SERVICE BULLETIN

94102 Quick Dump Valve Material Change

PX20X-X-X-B and PX30X-X-X-C Pumps and Service Kits

RELEASED: 11-23-11
REVISED: 1-10-12
Rev. 01
BULLETIN: #3-11

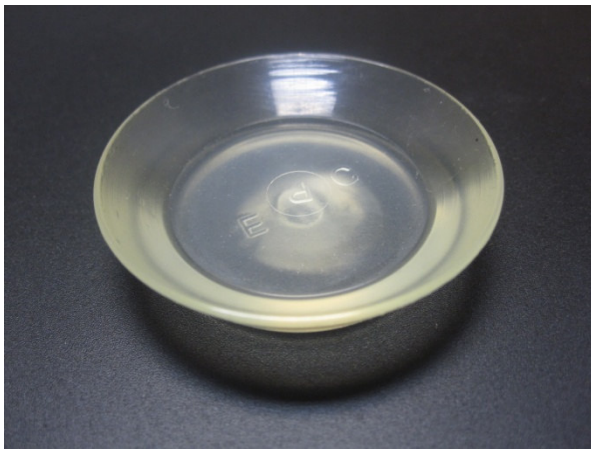
94102 Quick Dump Valve material is changed from urethane (TPU) to Santoprene (TPE) on all 2" and 3" EXP diaphragm pump models and service kits manufactured after 1 December 2011.
